## Executive Director's Recommendation

Commission Meeting: March 5, 2020

<b>PROJECT</b> <b>Uniformed Services University of the Health Sciences Education and Research Building</b> Naval Support Activity, Bethesda 8901 Wisconsin Avenue Bethesda, Maryland	<b>NCPC FILE NUMBER</b> 7987
<b>SUBMITTED BY</b> Naval Facilities Engineering Command Washington	<b>NCPC MAP FILE NUMBER</b> 3101.30(38.00)45071
<b>REVIEW AUTHORITY</b> Federal Projects in the Environs per 40 U.S.C. § 8722(b)(1)	<b>APPLICANT'S REQUEST</b> Approval of final site and building plans
	<b>PROPOSED ACTION</b> Approve final site and building plans as requested
	<b>ACTION ITEM TYPE</b> Staff Presentation

# Naval Support Activity Bethesda Uniformed Services University of the Health Sciences Education and Research Building

# LANDSCAPE ON PLAZA

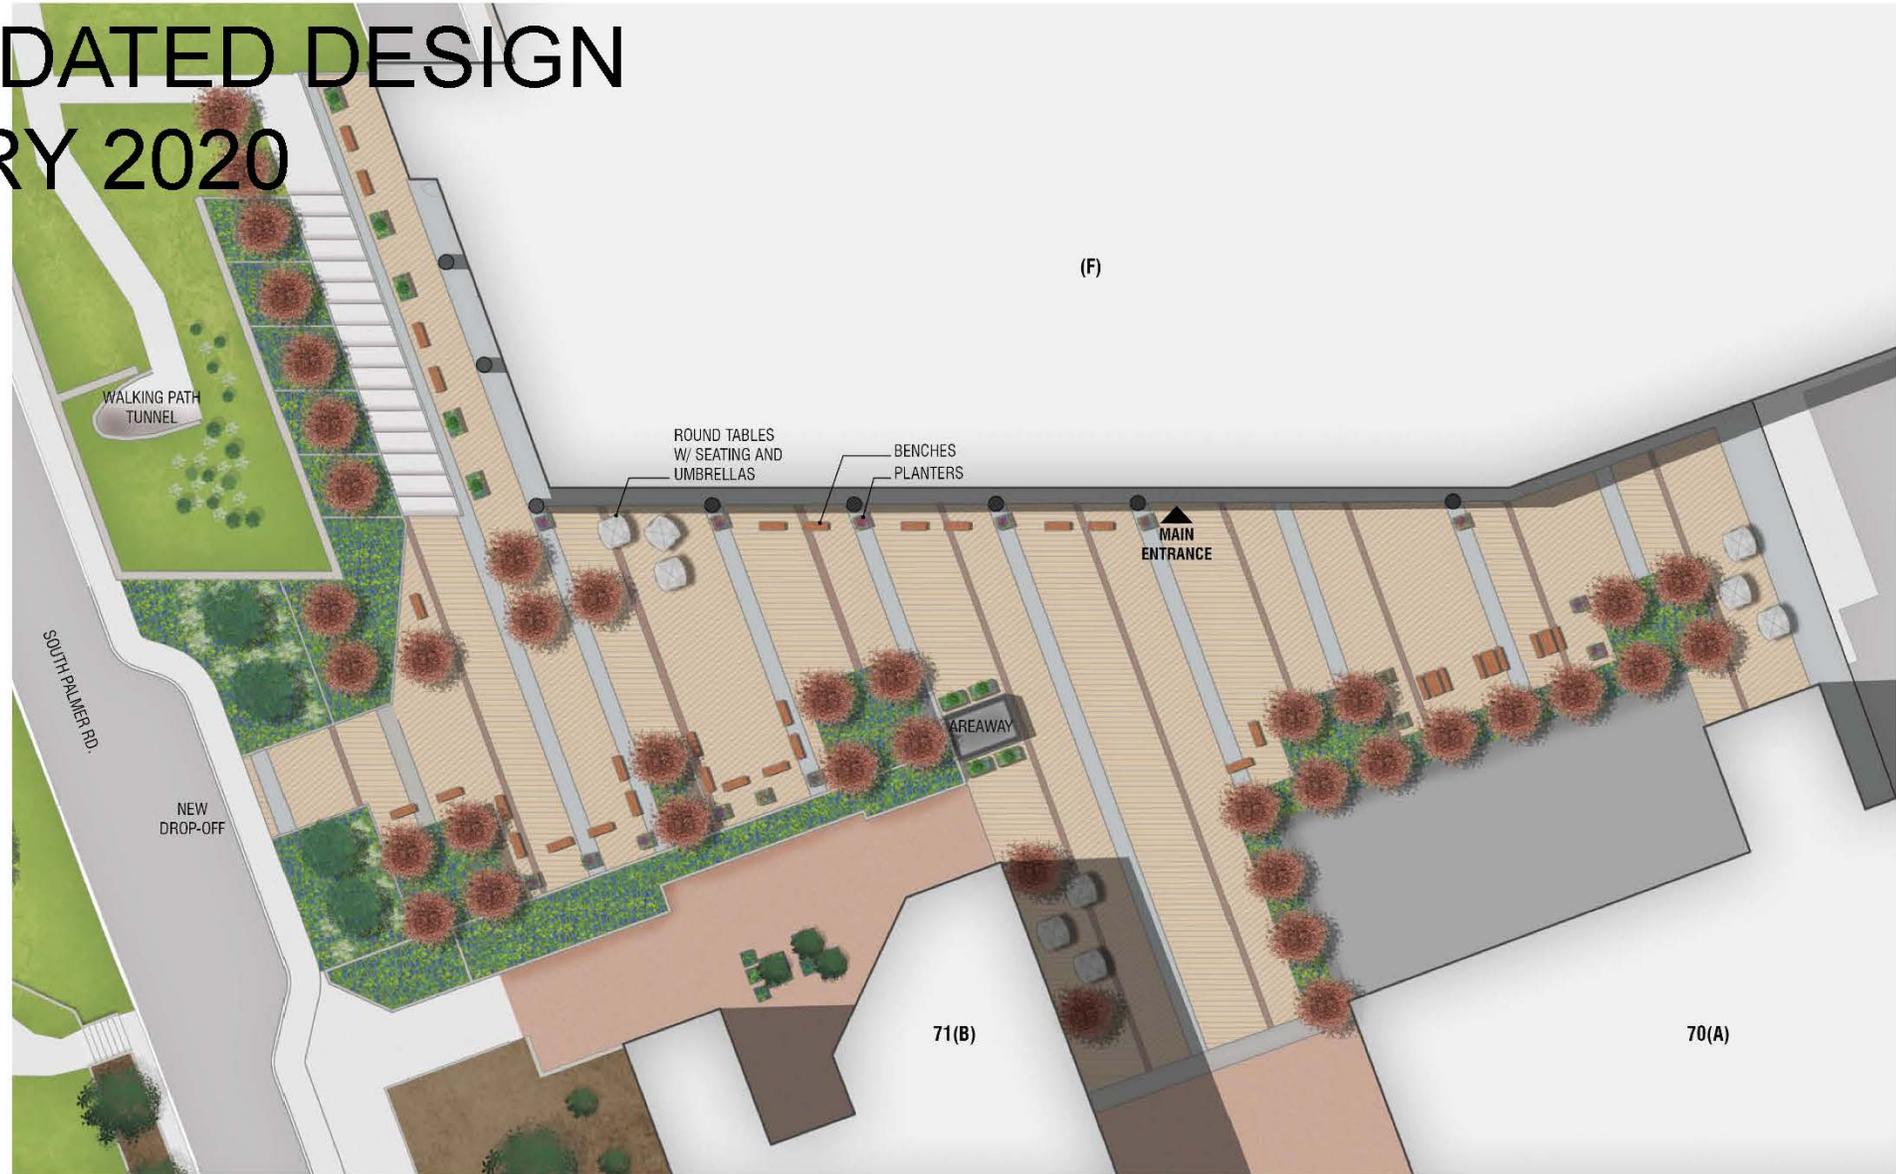
The preliminary landscaping plan for the plaza in June 2019 meeting consisted of nine medium sized trees (Japanese Maples) and eight shrubs. Some groundcover was also included in this design as well. During the meeting, the Commission commented on the preliminary plaza design as being sparse and insufficient for this campus.

After reviewing this submittal staff believes this final design is an improvement over the previous designs in several ways: the Navy has added a significant amount of new landscape to the plaza and the northwest stair including covered tables and benches. The final design includes 39 new trees, 71 shrubs and 8600 groundcover plants.

**Notes the Navy has added a significant amount of new landscape elements to the plaza and the northwest stair including benches and covered tables. The final design includes 39 new trees, 71 shrubs and 8,600 groundcover plants.**

**65% EXTERIOR  
PLAZA ON S.PALMER**

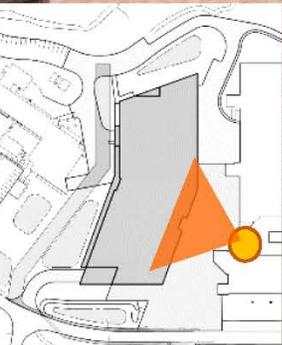
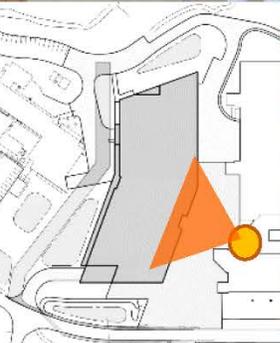
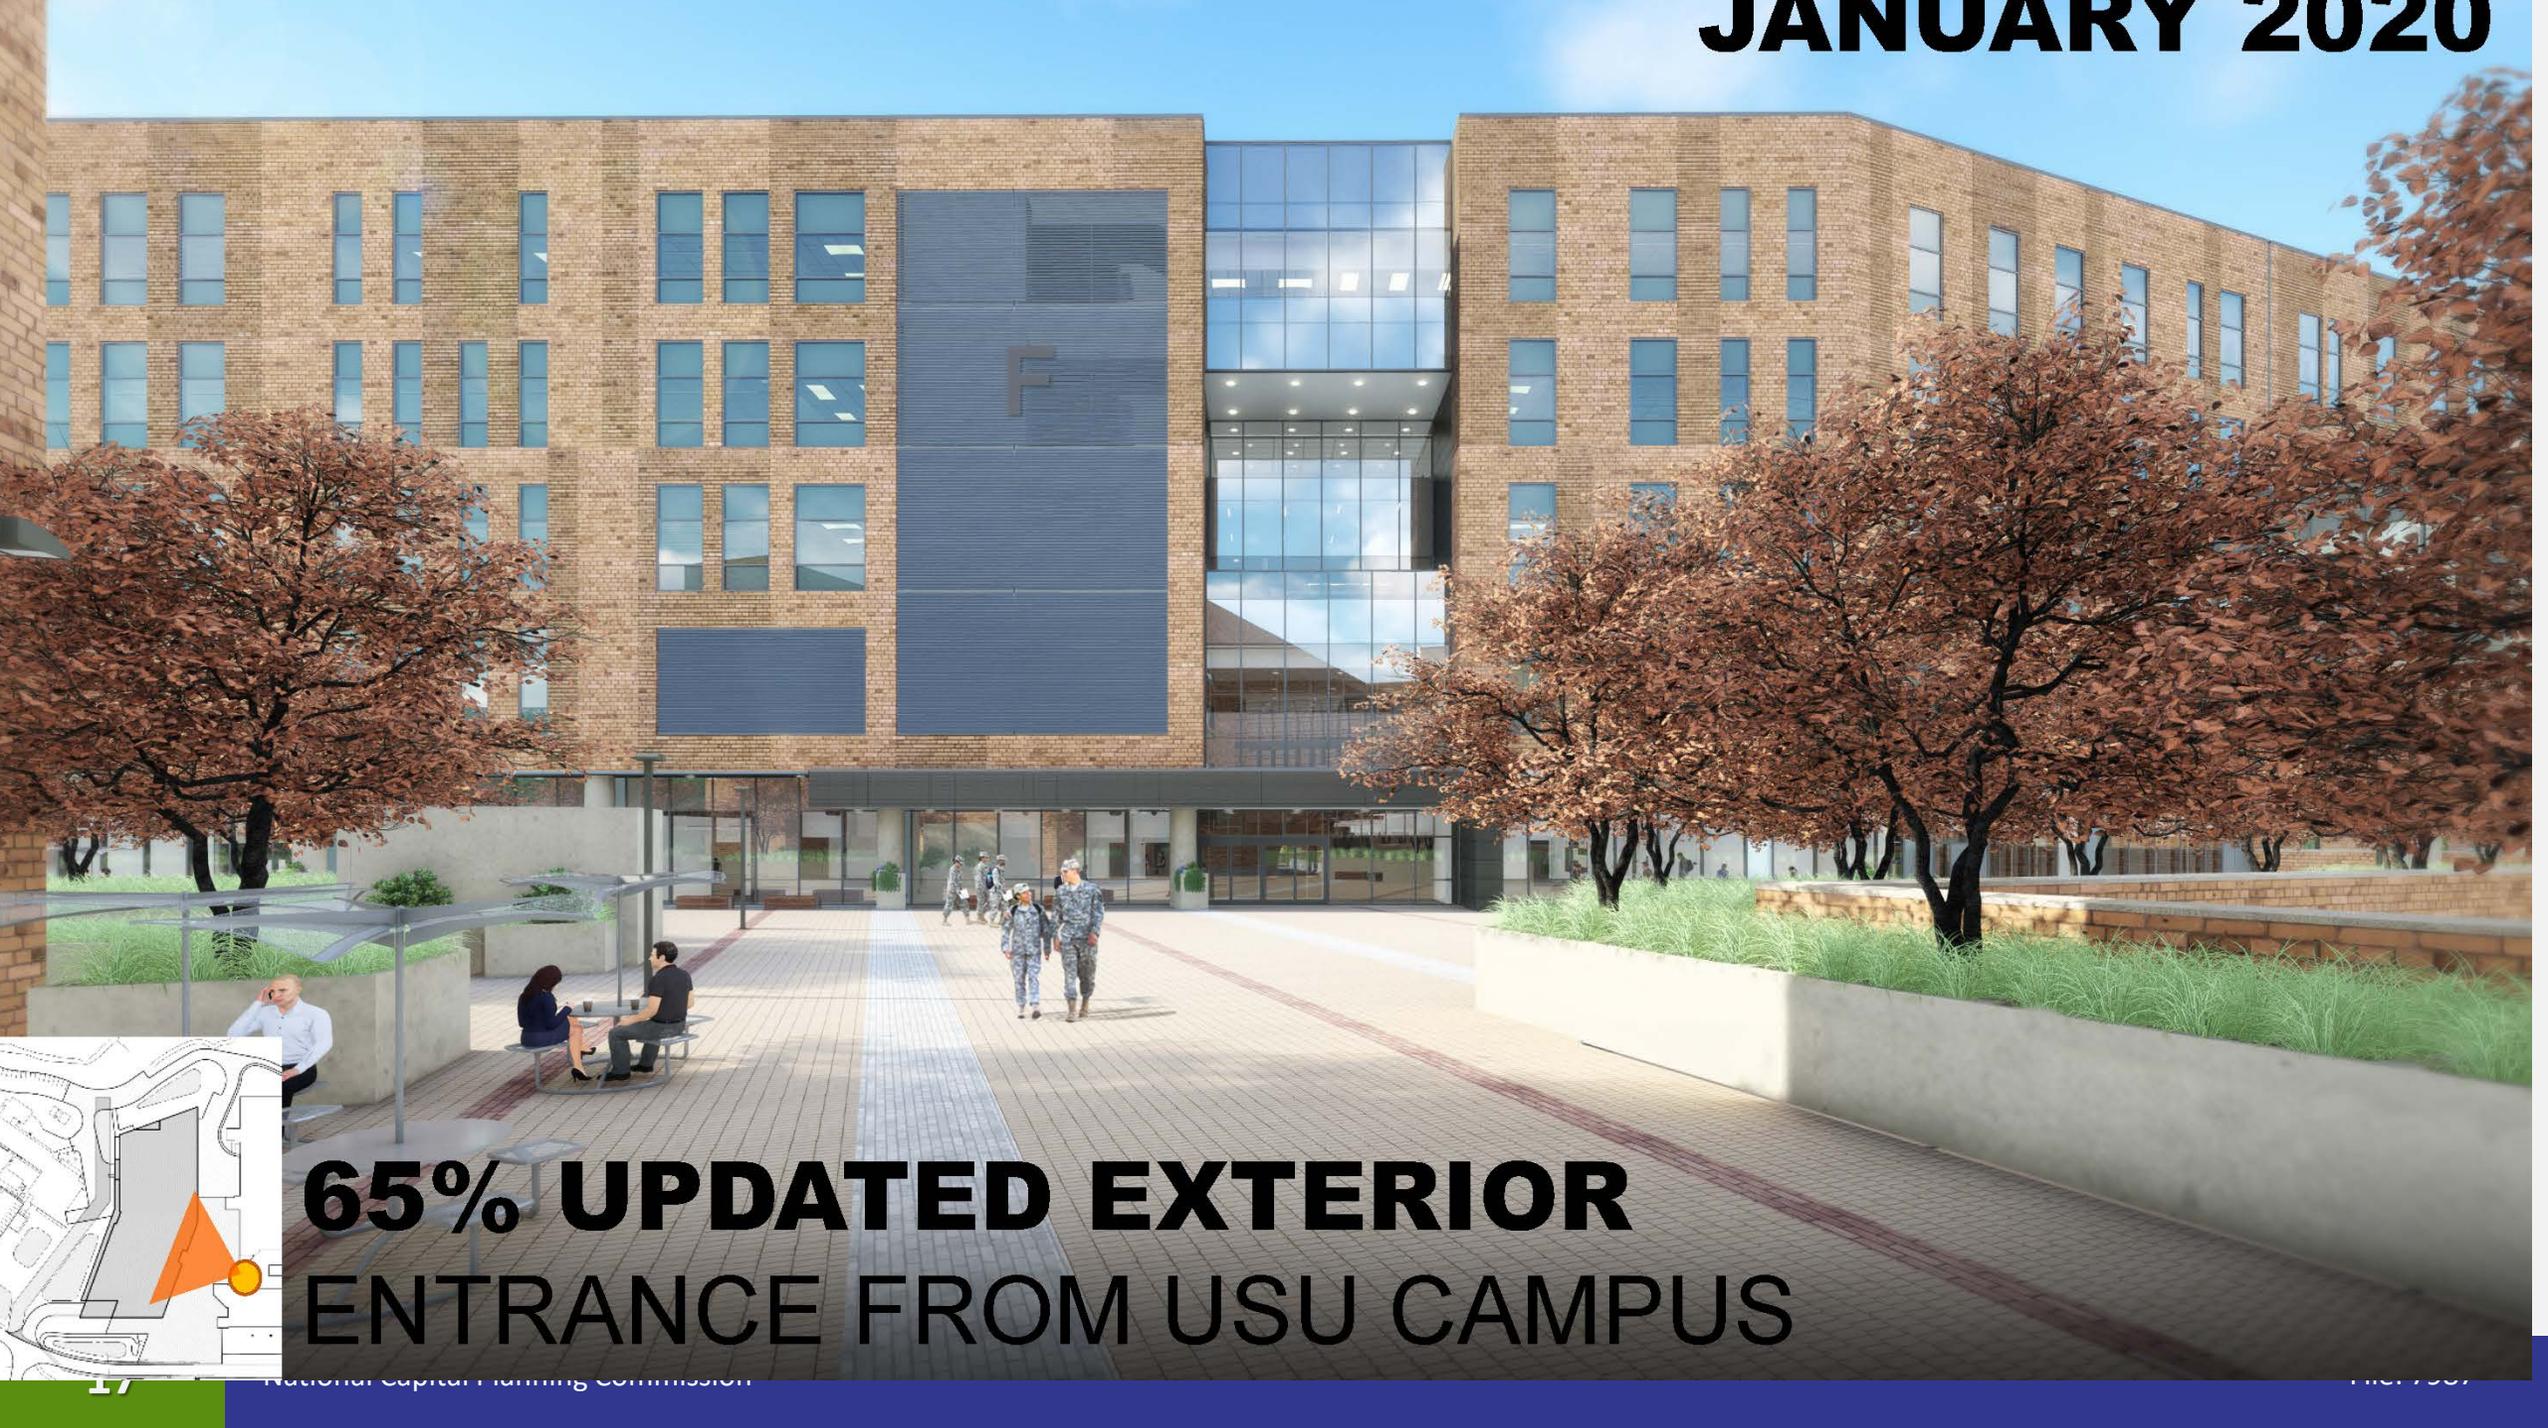
In the preliminary design, the main pedestrian connection leading from the western portion of Naval Support Facility Bethesda campus to the USUHS site was a set of steps located south of the proposed building that lead from a sidewalk up to the proposed plaza. While these steps didn't include any landscaping in the preliminary design, the final design includes a landscaped terrace area with seven understory trees and groundcover. These new trees will provide shade and a softer edge on the steps as pedestrians enter the plaza from the sidewalk.
